LARAMIE COUNTY PLANNING & DEVELOPMENT DEPARTMENT

TITLE: PUBLIC HEARING: Continued from November 4th, 2025, a Subdivision Permit and Plat for The Life, Laramie County, WY.

PZ-25-00064

THE LIFE
SUBDIVISION

THE LIFE

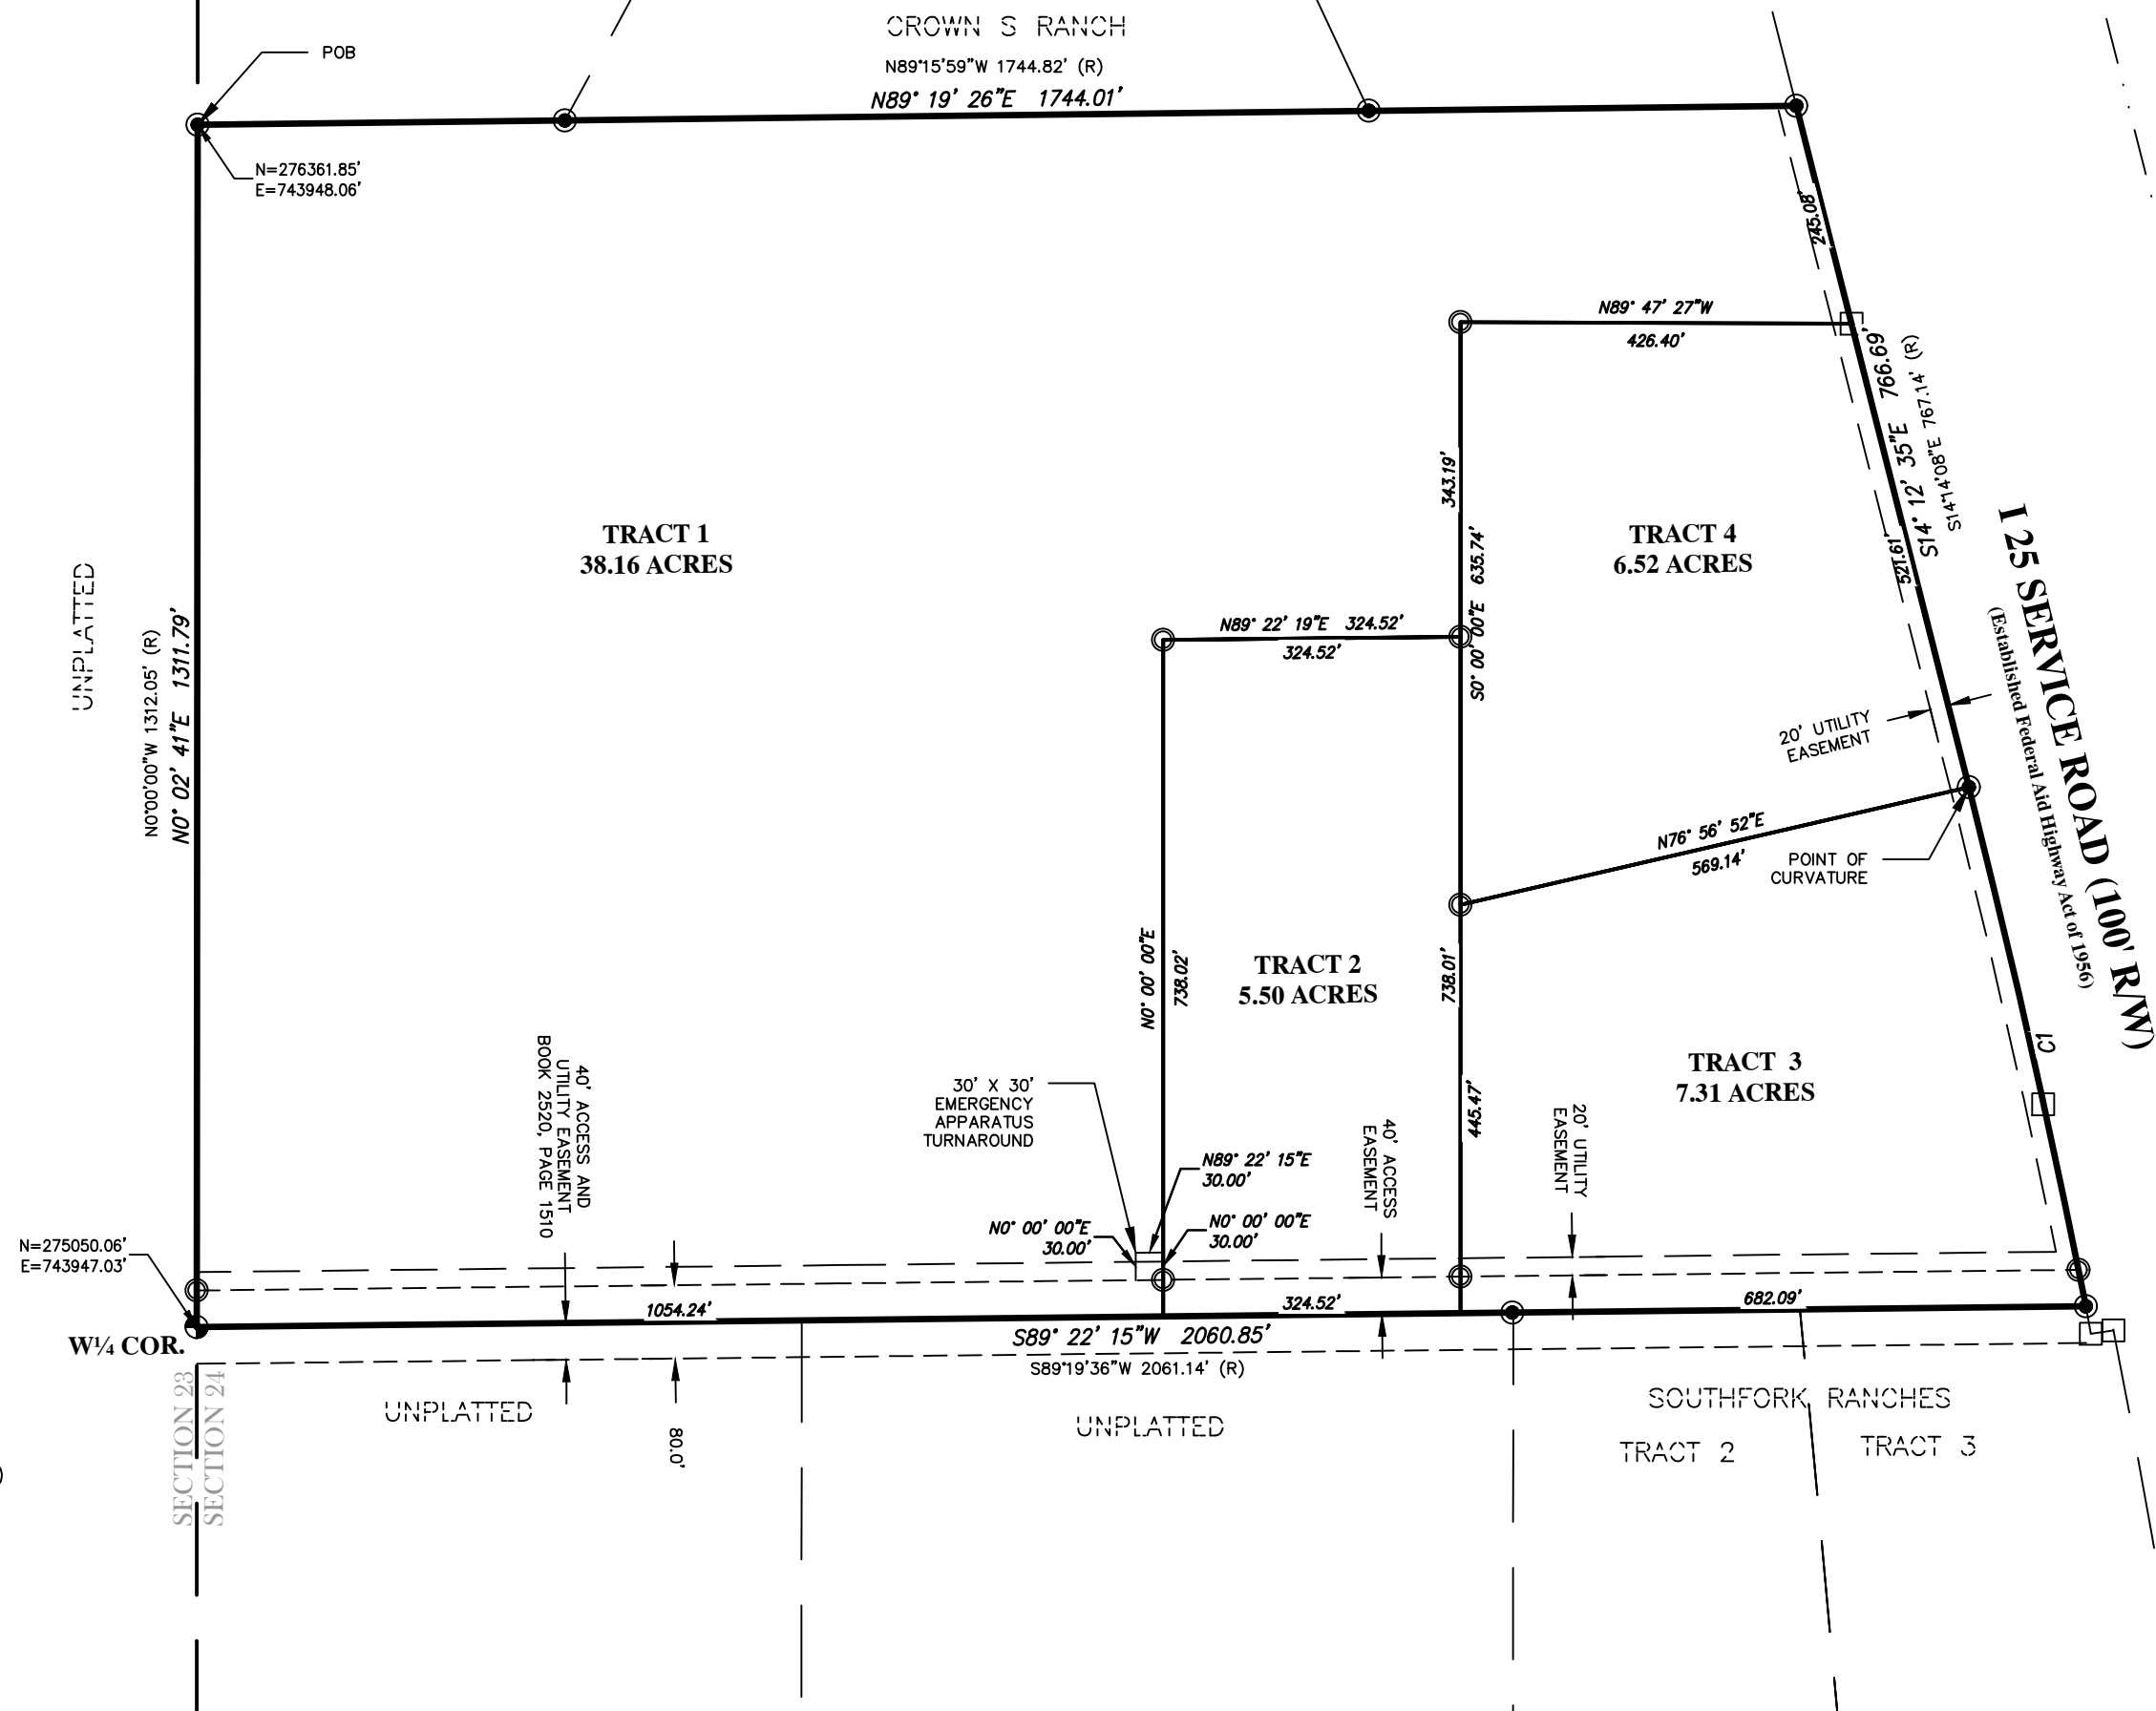
6.Per 4-5-102.c. the plat drawing shall include the following items: 14.) Plats that show adjacent or internal existing roadways and rights of way shall indicate on the plat how the roadway was established (i.e., dedicated to the public via plat, petition, declared, etc.). How was the I-25 Service Road established? 21.) A legend that defines all the various symbols, line types, shading/hatching, etc. used in the drawing. The legend shown on the plat only defines symbols, but not line types.

7.The Tract numbers for Tracts 2 and 3 of the Southfork Ranches should be labeled on the plat drawing.

1.Per 4-5-102.c. the plat drawing shall include the following items: 4.) Dedication and acknowledgment statements must be executed by all owners of legal and equitable interests in the property being subdivided/developed. The acknowledgement shall be located near the dedication on the plat. The dedication of right of ways and easements is mentioned in the DEDICATION, however it does not define if

they are dedicated to the public or for any other purpose. 10.) For subdivisions in the County, survey tie(s) by bearing/azimuth and the distance to the nearest public land survey system monument shall be accurately described on the plat. In addition, for the purposes of enhancing the City and County GIS Program framework, all public land survey corners on or within the subdivision boundary shall have field observation coordinates provided on the plat. These coordinates shall reference Wyoming State Plane Coordinate System, East Zone, U.S. Survey foot, NAD 1983(CORS96). The coordinates shall be observed and verified at the time of the plat survey. There are no Wyoming State Plane field observation coordinates shown on the plat. 16.) Where applicable, curve data showing the radius, central angle, arc length, chord bearing/azimuth and distance and any notation of non-tangent curves. The location of points of curvatures and intersections shall be shown. The point of curvature for the curve on the east boundary of the subdivision should be shown. 18.) The right-of-way lines, widths and names of all streets, roads, and easements within and adjacent to the proposed subdivision/development. What is the width of the I-25 SERVICE ROAD portion of I-25?

4.Per 4-5-102.c. the plat drawing shall include the following items: 14.) Plats that show adjacent or internal existing roadways and rights of way shall indicate on the plat how the roadway was established (i.e., dedicated to the public via plat, petition, declared, etc.). How was the I-25 Service Road established?

5.Per WYDOTs comments and per the County (i.e., in general developers should utilize internal roadway networks whenever possible and in this case there is no reason Tract 1 would need access off the service road), Note 6 needs to be changed to indicate Tracts 1, 2 and 3 shall be accessed off the roadway in the easement and only Tract 4 shall access from I25 Service Road.

<p>1. ack</p> <p>2. ack</p> <p>3. ack</p> <p>4. ack</p> <p>5. the note will remain as is. We have wydot approval per taylor mccort.</p>
